Instructions to Voters/Comments on API 520 Part I Ballot – “Reynolds Number for Liquids”

- Your comments should be limited to the **red-lines portions of the ballot only.**
- This ballot covers the API 520 TF action item 2024-10. This was initiated by RFI 10106.
- If you are voting negative, please indicate which of your comment or comments are the reason for your negative vote. API’s Balloting system will categorize all of your comments as Negative.
- Don’t worry about formatting issues, particularly with the equations since these are a mess. These will be fixed during final editing.

Sizing, Selection, and Installation of Pressure-relieving Devices

API STANDARD 520, PART I
TENTH EDITION, OCTOBER 2020

Figure 38—Capacity Correction Factor, K_v , Due to Viscosity

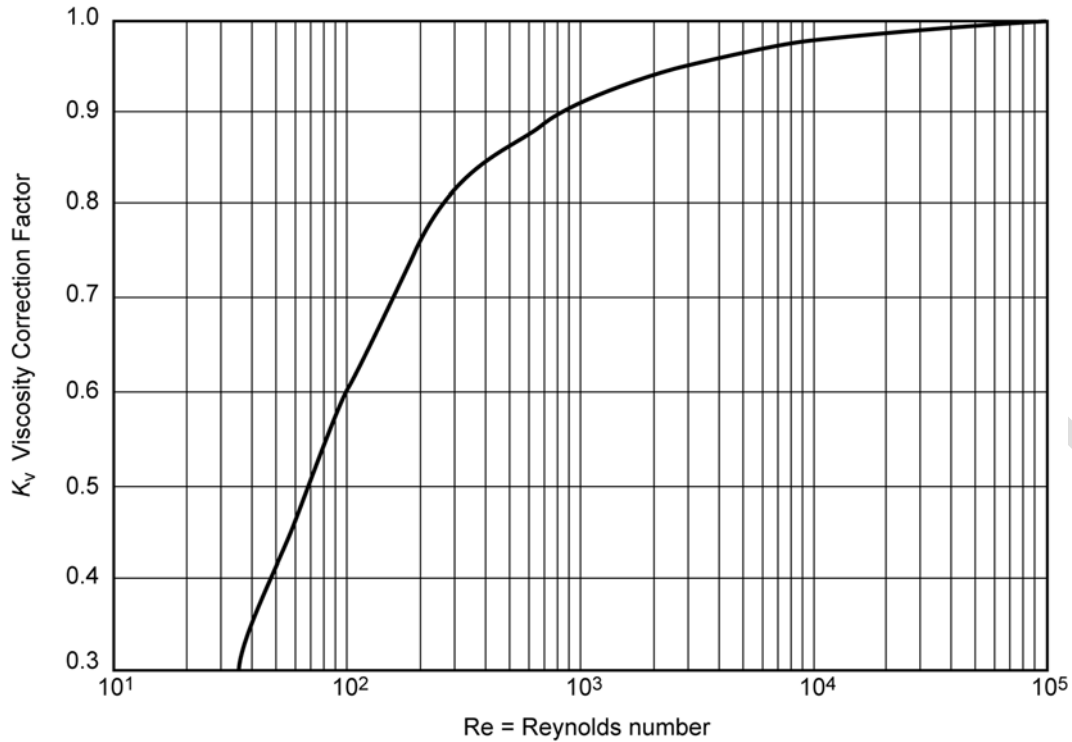
Editors Note: The X-axis label in Figure 38 needs to be updated to Re_L .
